SERVICE BULLETIN SB98.11

Machines/Models: AB46 Electric & Bi-Energy

PURPOSE: To ensure proper plug braking.

OPERATION REQUIRED: Rewire electric circuit.

Figure 1

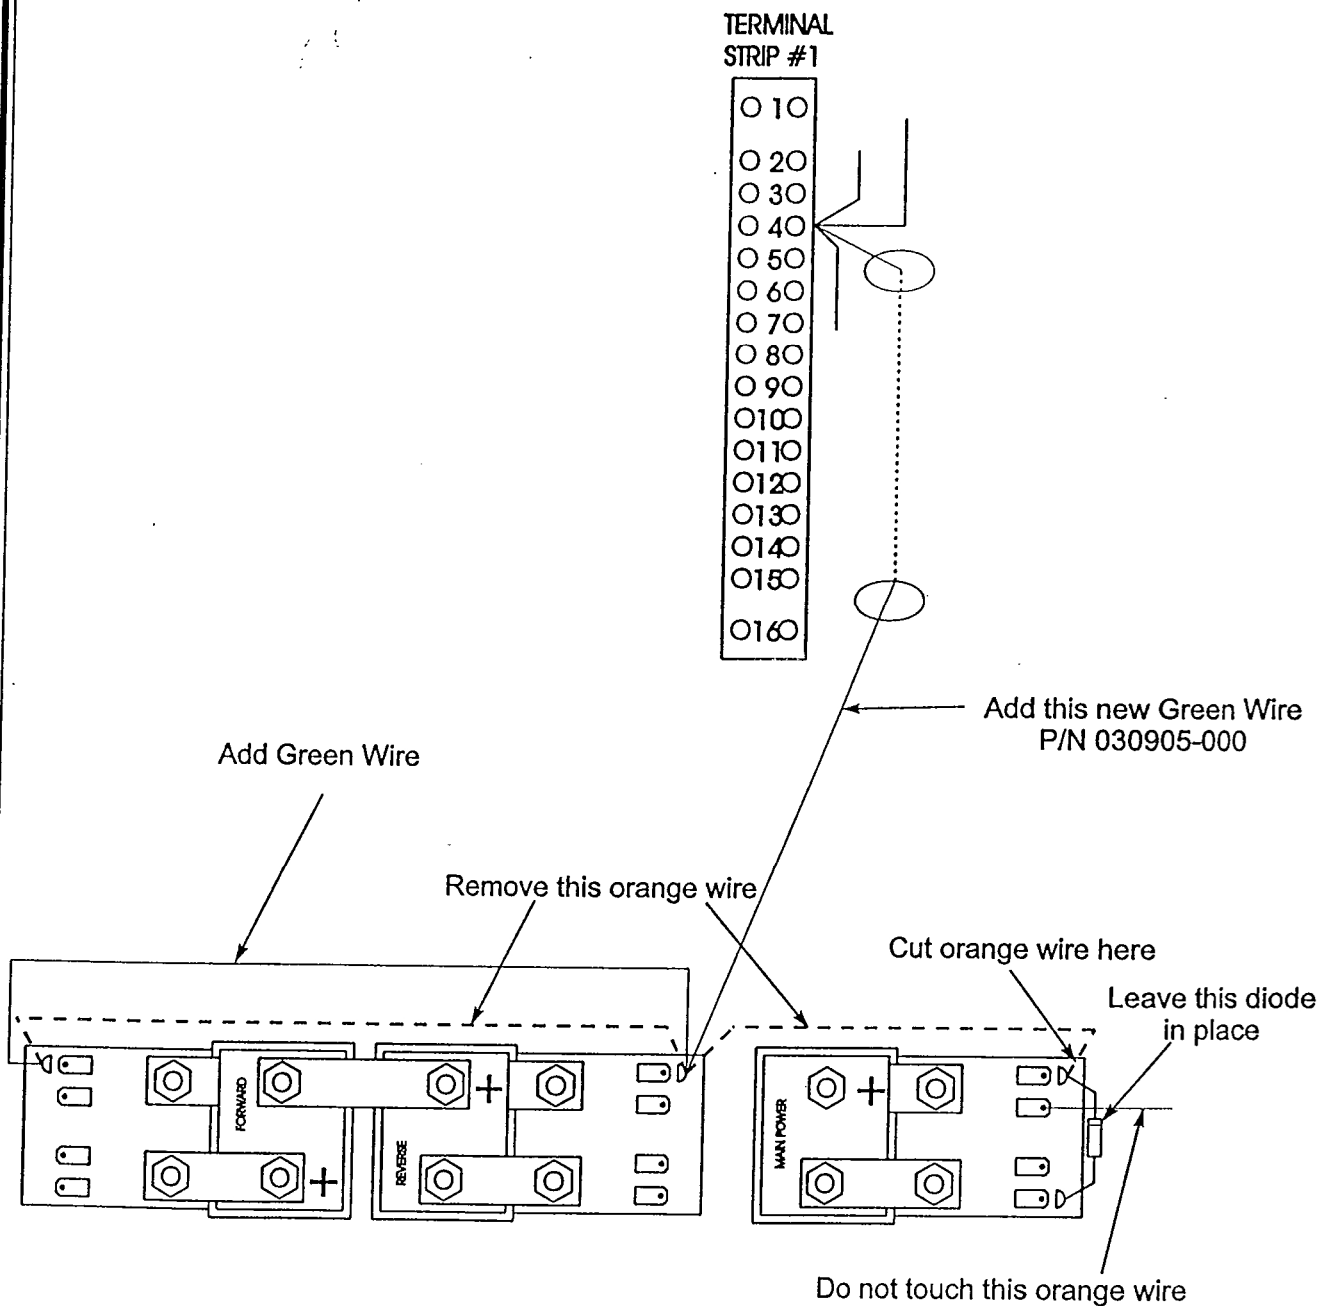
PARTS REQUIRED: Jumper wire assembly (# 030905-000)

1. Unplug battery connectors.
2. Remove engine compartment cover.
3. Remove electrical panel cover.
4. Locate orange wire attached to contactors (Figure 1).
5. Cut orange wire at diode connection on main power contactor.
6. Leaving diode in place, remove orange wire.
7. Install green wire on to forward and reverse contactors (Figure 1).
8. Insert green wire as shown, through holes in panel and attach to terminal #4.
9. Reinstall covers.
10. Connect batteries.
11. Perform full test of drive functions.
